Please read our NPC25001 (notification of product change).

Carrè, 07.05.2026
Our ref.: NPC25001 ES58-EM58-HS58-HM58-HSCT-HMCT

Subject: Notification of Change to:

ES58, EM58, HS58, HM58, HSCT & HMCT Series

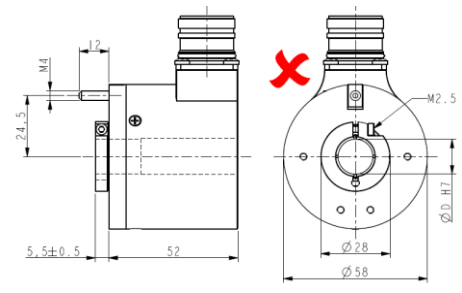
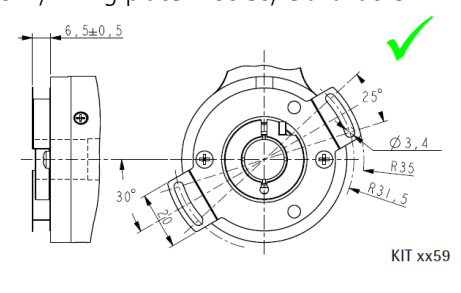
Compared to the old ES58, EM58, HS58, HM58, HSCT & HMCT series the new products have better performance and a more modern design.

The above-mentioned products will gradually be replaced by the new EHM58, EHO58 and EHCT59 series (see attached datasheets). In case of HSCT and HMCT the replacement will be immediate.

Special "replacement" models will be created to grant maximum backward compatibility for spare part purposes. These models will be based on the above-mentioned new series, but offer bigger options variety. They can be identified with R.EHM58, R.EHO58 and R.EHCT59.
